Architect's Supplemental Instructions Addendum

Project: Samish Xwch'ángteng Development on 34th Street
Anacortes, WA

Addendum/ASI No.: Addendum 04
Date of Issuance: June 3rd, 2022

ATS

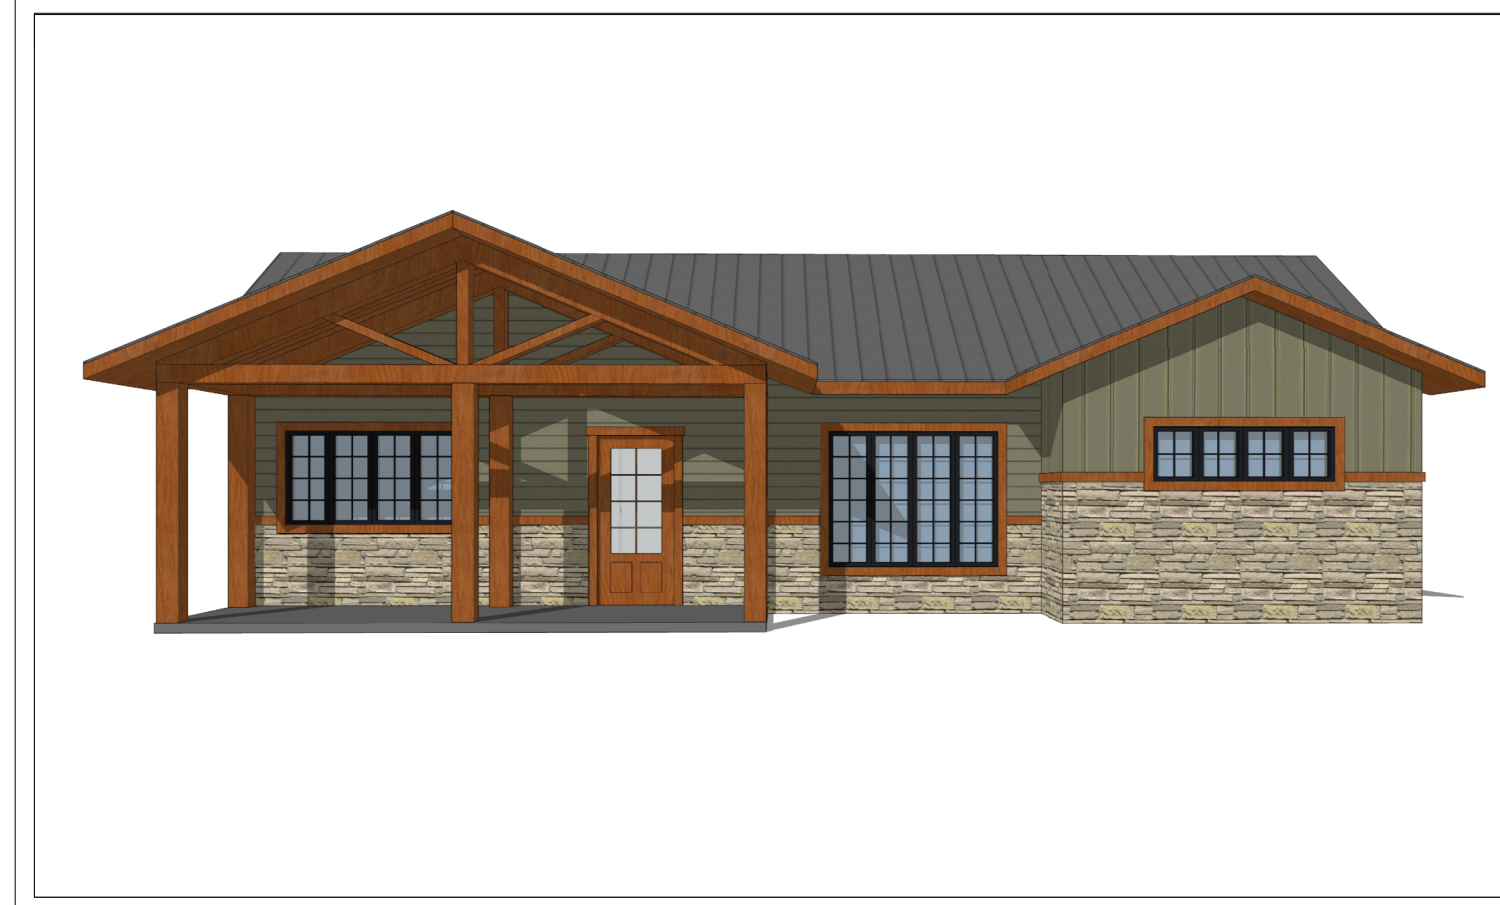
1. Sheet ATS: add [DEFERRED SUBMITTALS LIST](#)
2. A200, A201, A202, A203, A204, A300, A301, A302, A303, A304, A305 note #18 add [MAXIMUM 5 AIR CHANGES PER HOUR. A BLOWER DOOR TEST IS REQUIRED BY THE WASHINGTON STATE](#)

DEFERRED SUBMITTALS
-FIRE SPRINKLERS (FIRE MARSHAL AND MEP TO REVIEW)
-PREFABRICATED WOOD TRUSSES
-ENGINEERED I-JOISTS

SHEET
A200

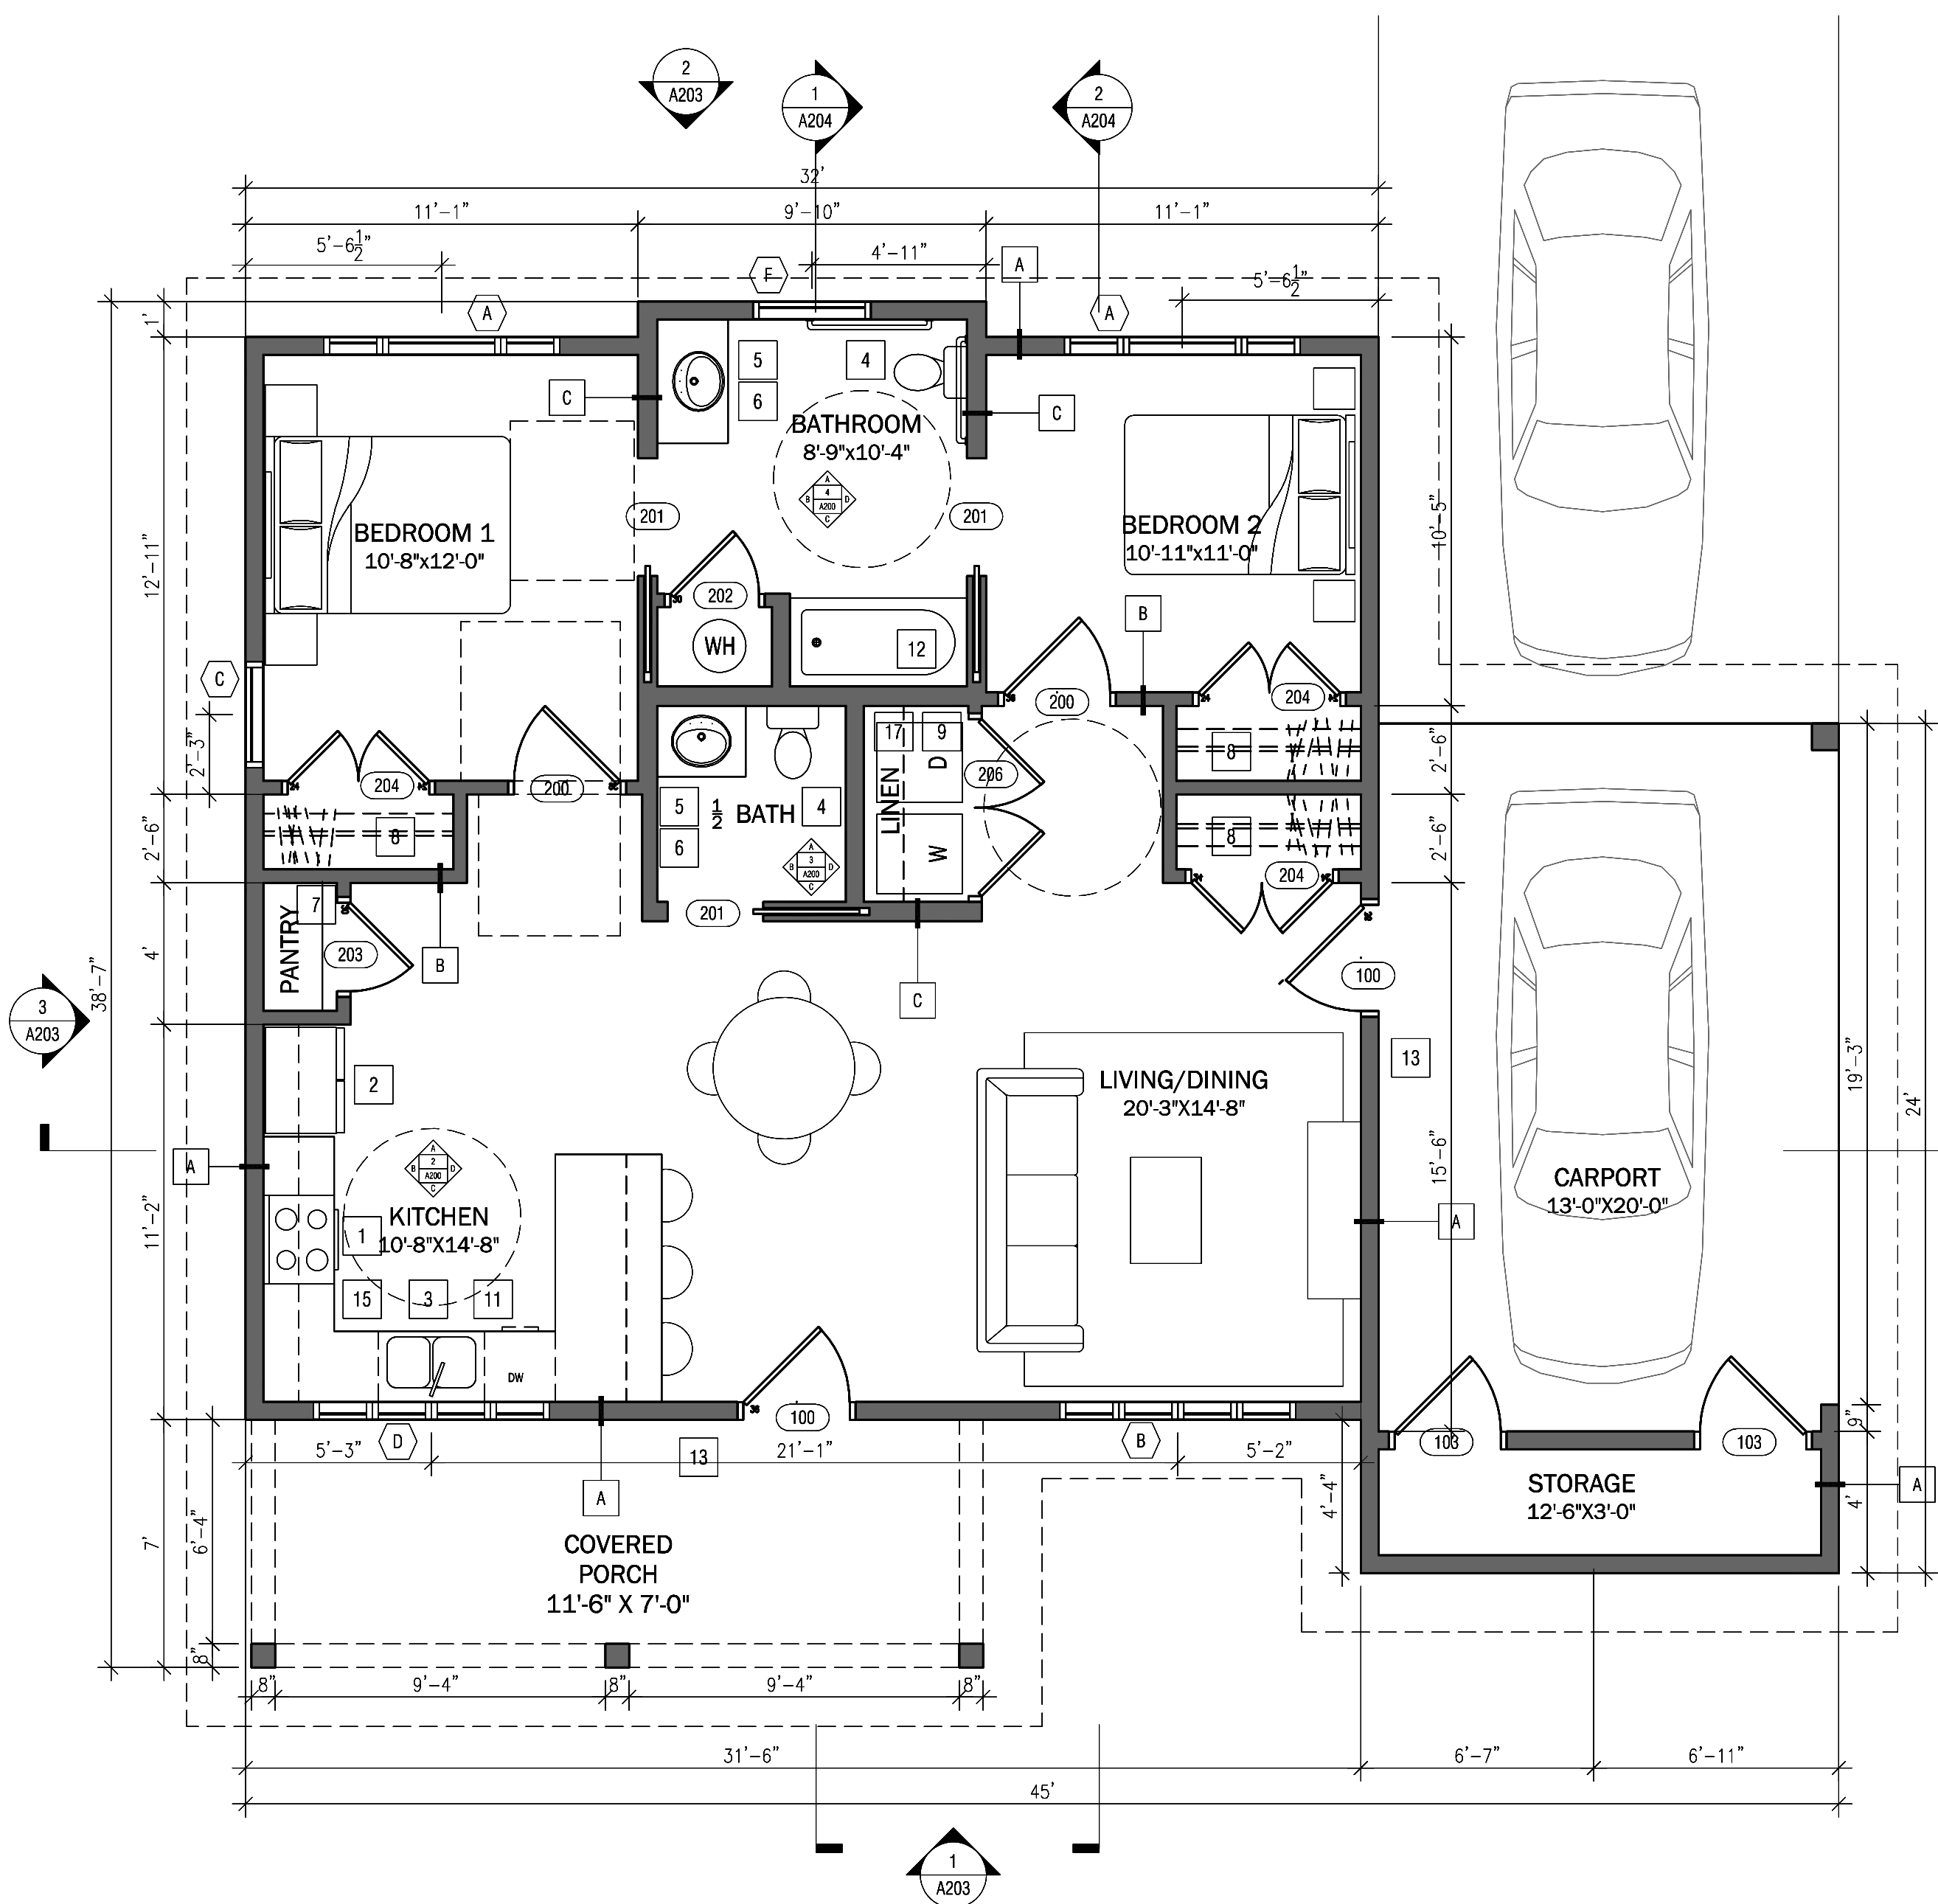
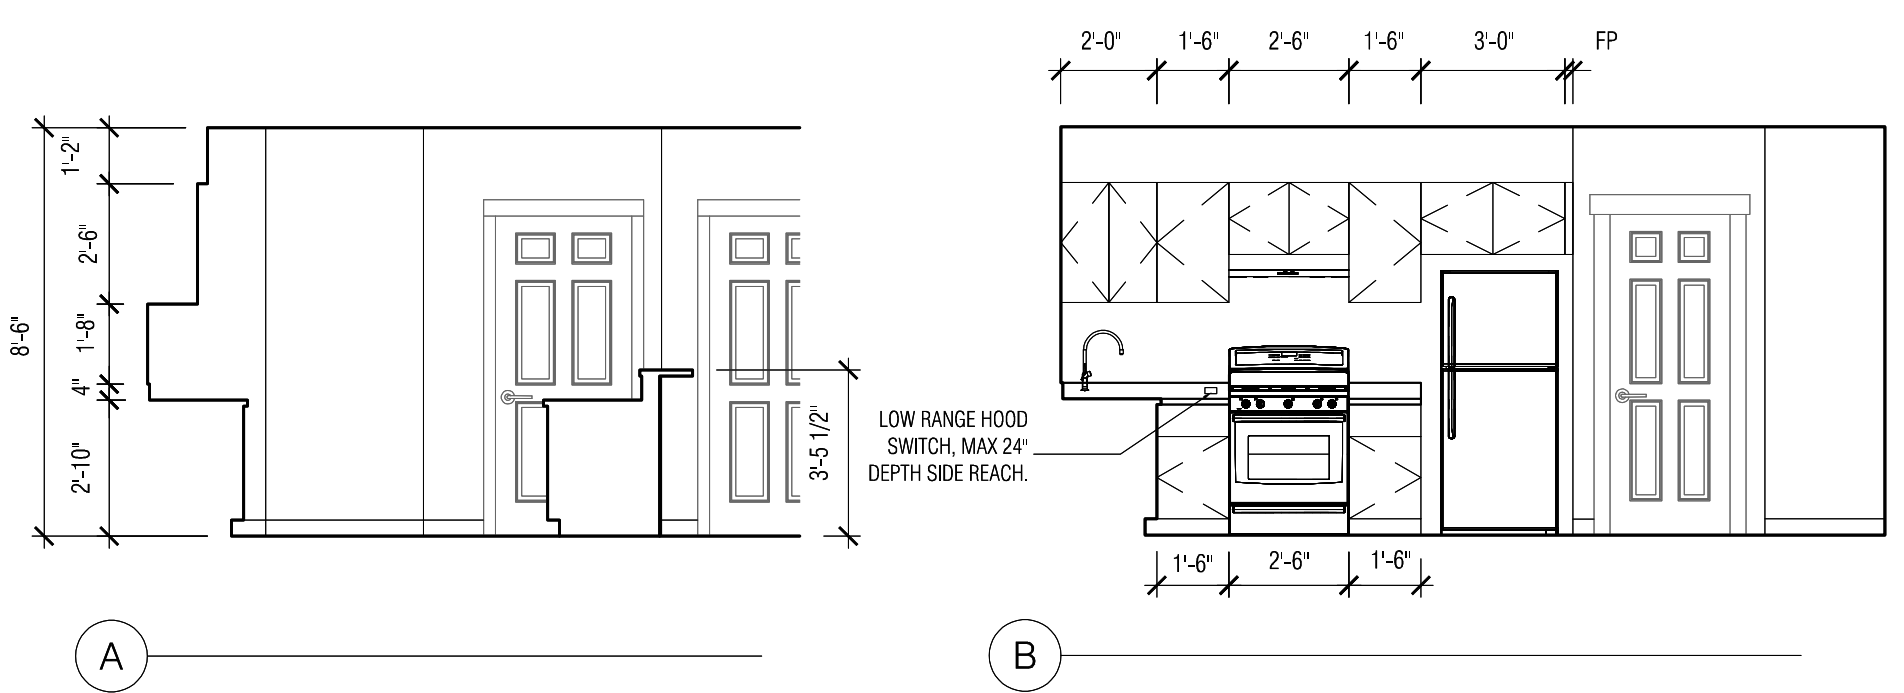
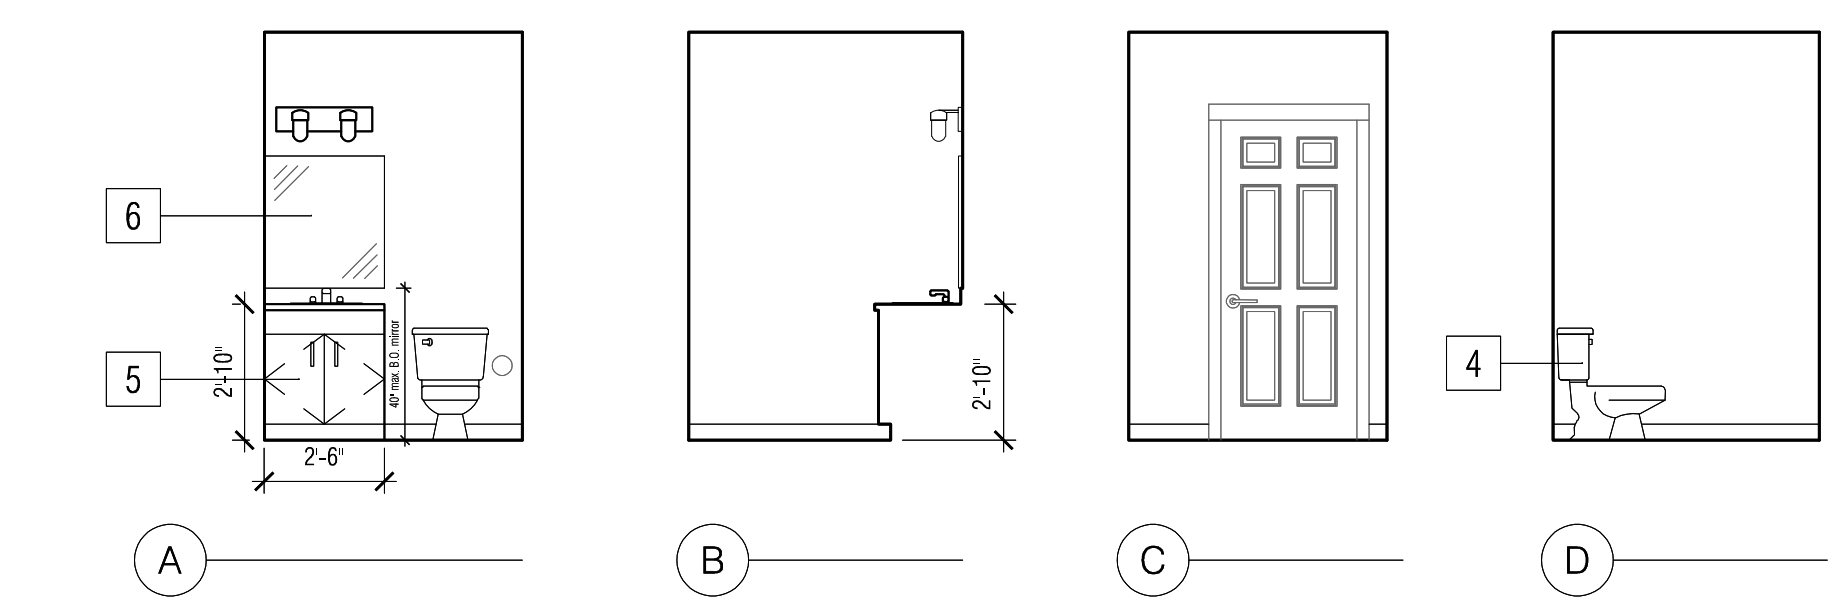
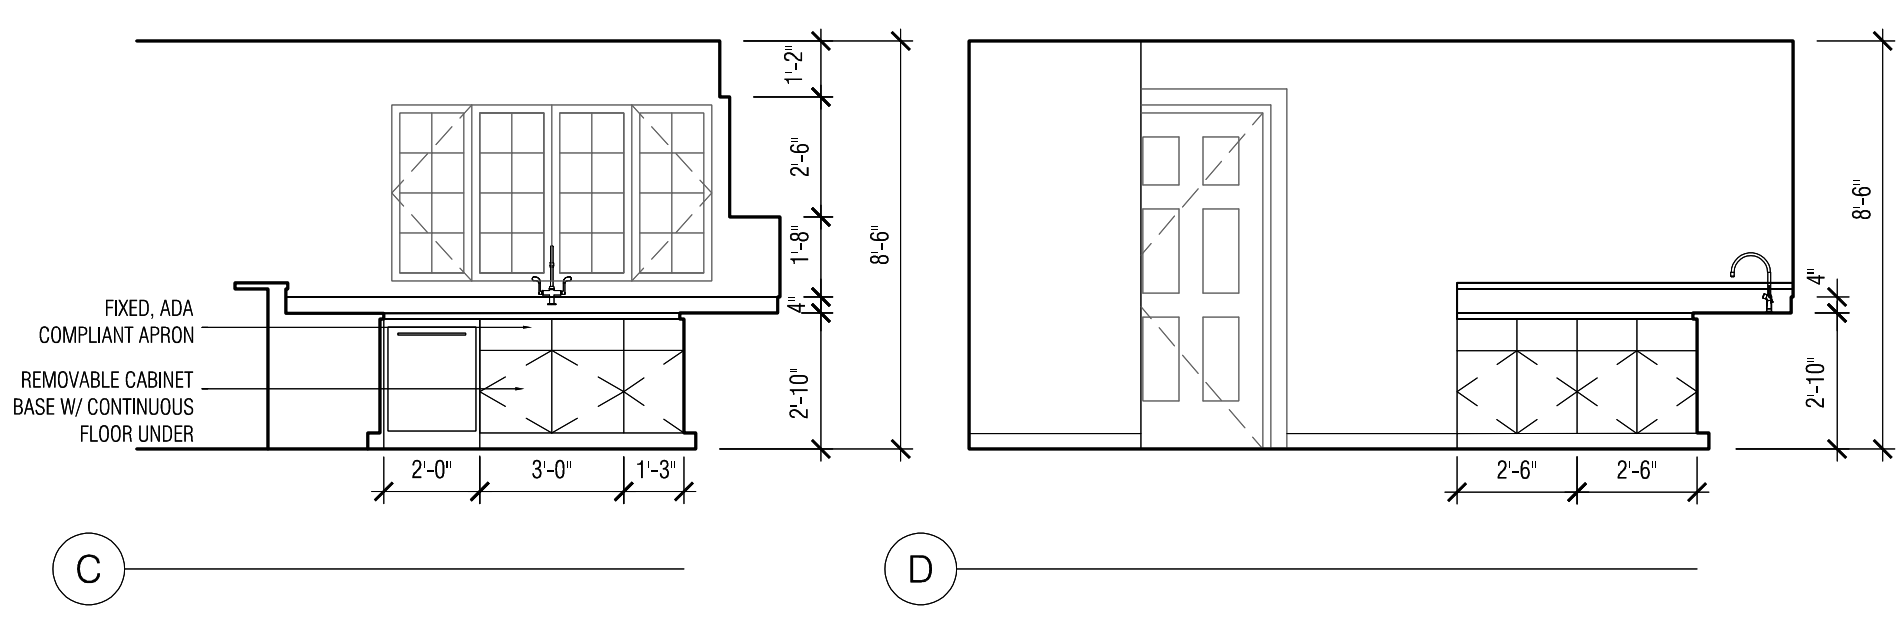
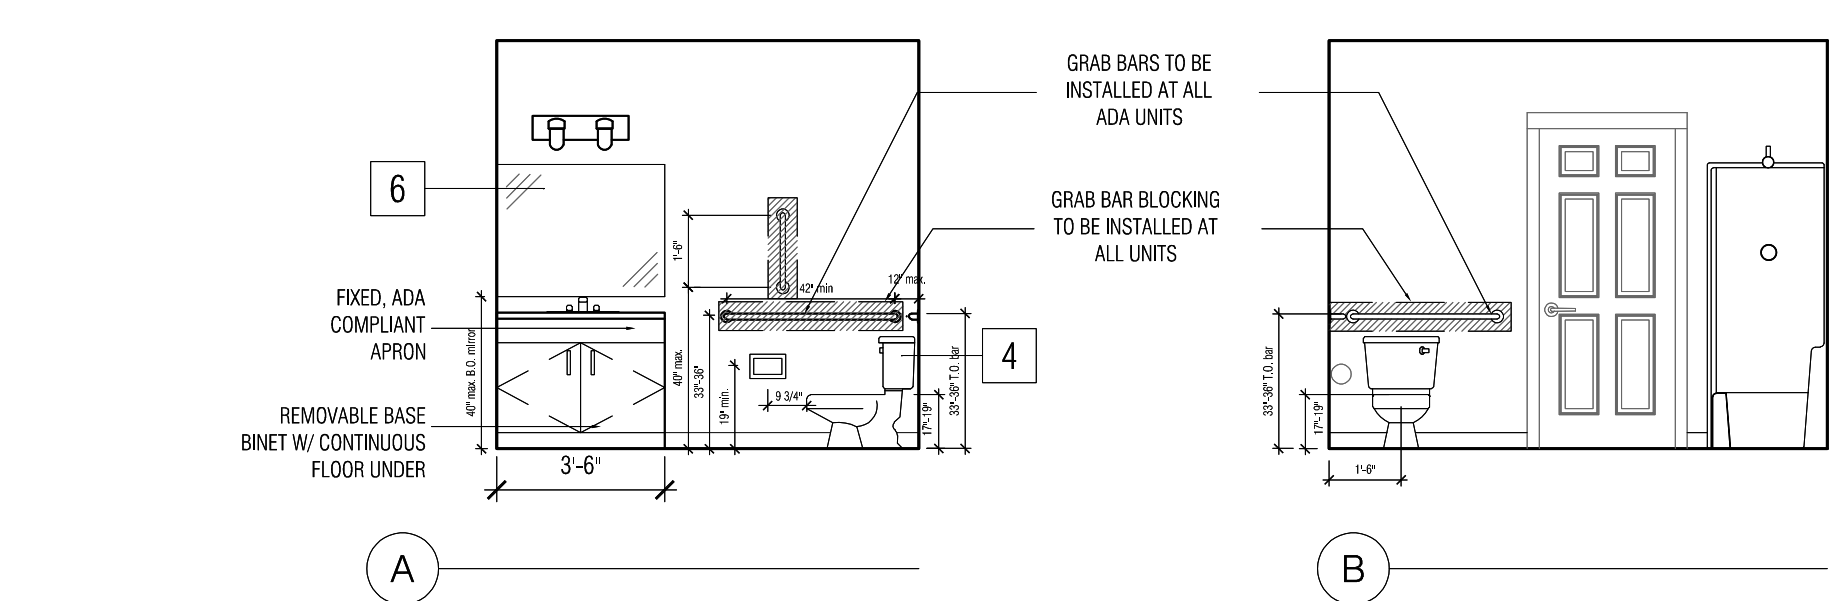
ENERGY CODE R402.4.1.2 TESTING FOR EACH HOUSING UNIT. TEST TO BE PAID AND
COORDINATED BY CONTRACTOR

- PROVIDE PASSIVE RADON SYSTEM PER MEP SHEETS & DETAIL 3/A402
- ALL INTERIOR PAINTS MUST COMPLY WITH GREEN SEAL STANDARDS FOR LOW VOC LIMITS
- BUILDING ENVELOPE TO HAVE AN AIR LEAKAGE RATING OF LESS THAN OR EQUAL TO 0.40 CFM/SQ.FT. MAXIMUM 5 AIR CHANGES PER HOUR. A BLOWER DOOR TEST IS REQUIRED BY THE WASHINGTON STATE ENERGY CODE R402.4.1.2 TESTING FOR EACH HOUSING UNIT. TEST TO BE PAID FOR AND COORDINATED BY CONTRACTOR.
